Suggestions for Field Cage Assembly Table Improvements

UTA HEP

January 14, 2020

I-beam support is 12 cm higher than the profiles – 4 total

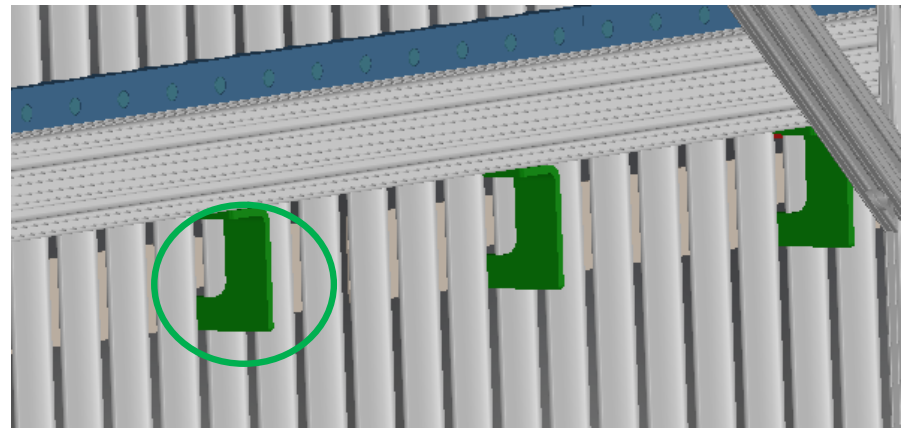
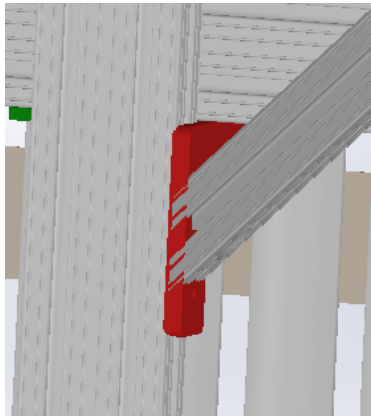
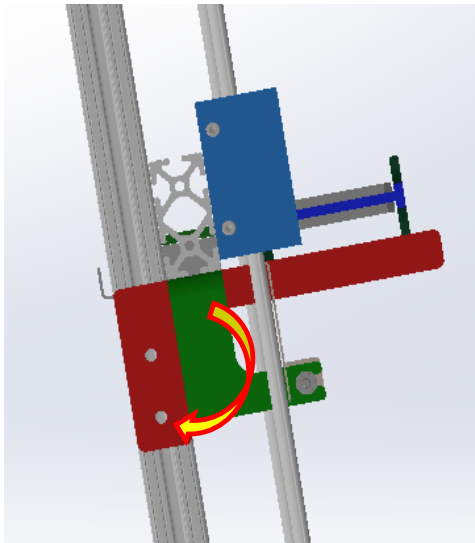
- Parts protruding past the height of the aluminum profiles may catch the profiles during lifting.
 - If 1 mm height difference on the profile divider was enough to raise concerns, surely the I-Beam support and profile nut stopper supports should be re-evaluated.
 - Both of which are much greater than 1 mm. *Seen on pg. 3

- 4 total: In addition to the protrusion, two cannot be placed in the location in the current design due to large interferences with the assembly table frame
- Ideas to eliminate the need to unmount the I-beam support bar after every module completion:
 - Allow for pivoting motion on corner of support piece. (Will need a bearing?)
 - Use spring plunger that allows for locking. Ideally, we should just be able to disengage the ball to allow the support bar to swivel down.

Profile slip nut support is 2.7 cm higher than profiles – 16 total

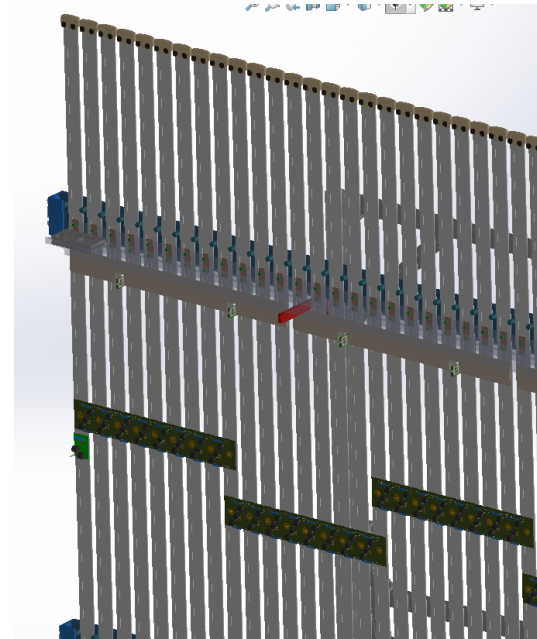
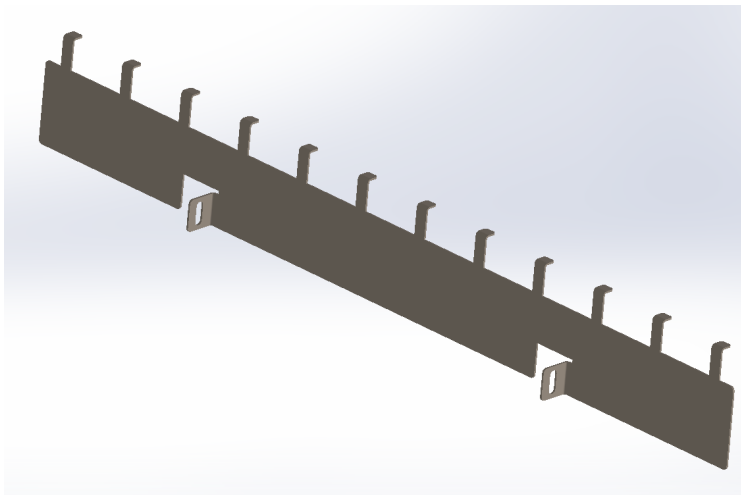
- Purpose of the stopper is to align the slip nuts with the holes on the I-beam.
- Stopper must be easily mounted and unmounted to reduce total time to complete a module
- Also the current design of the stopper uses a support structure that will significantly interfere with the aluminum profiles during lifting unless removed (which will waste time)
